# Notice of Modification

## Section 4.55(1A) of the Environmental Planning and Assessment Act 1979

The development consent (SSD 7538) for the Broken Hill North Mine Project, granted by the Executive Director, Resource Assessments and Business Systems on 22 December 2017.

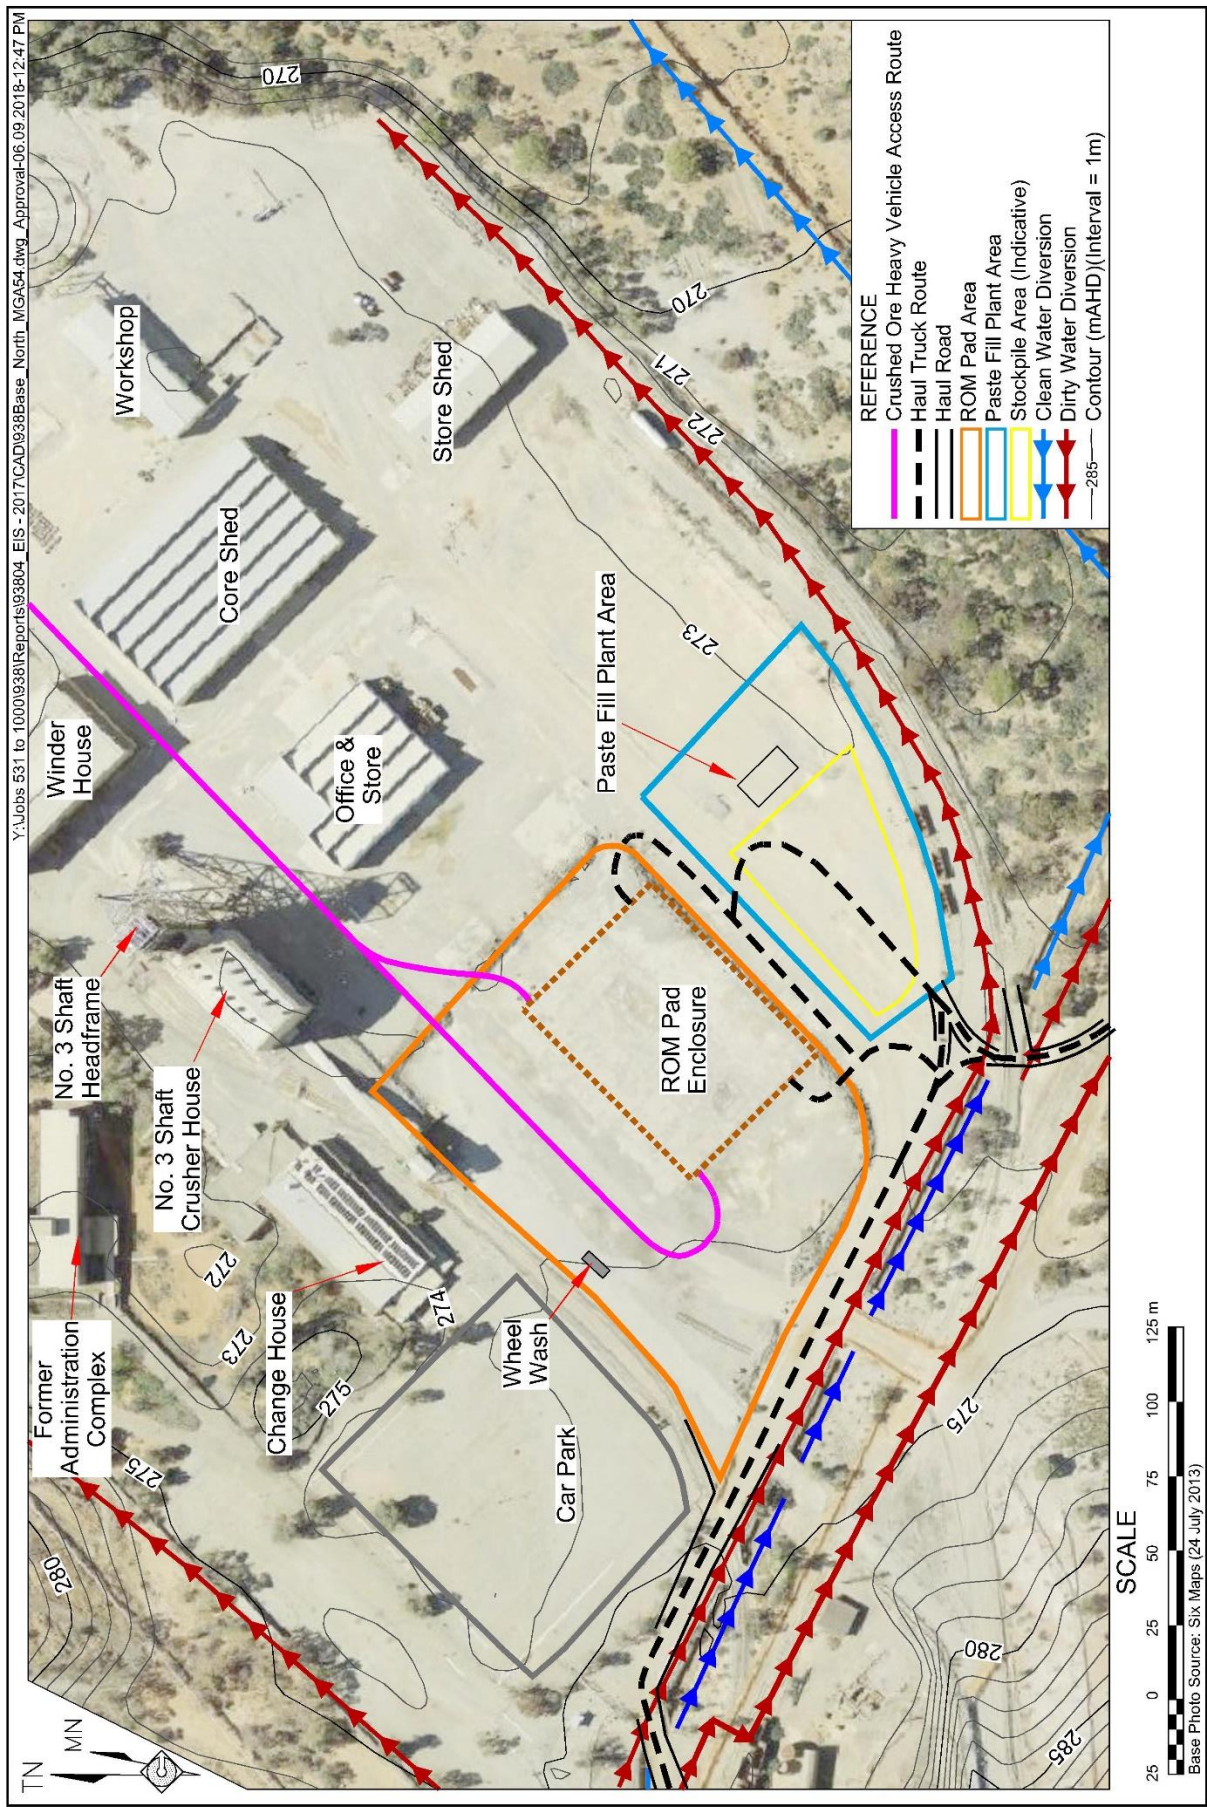
5. In APPENDIX 2, delete the first figure only and replace with the following figure:
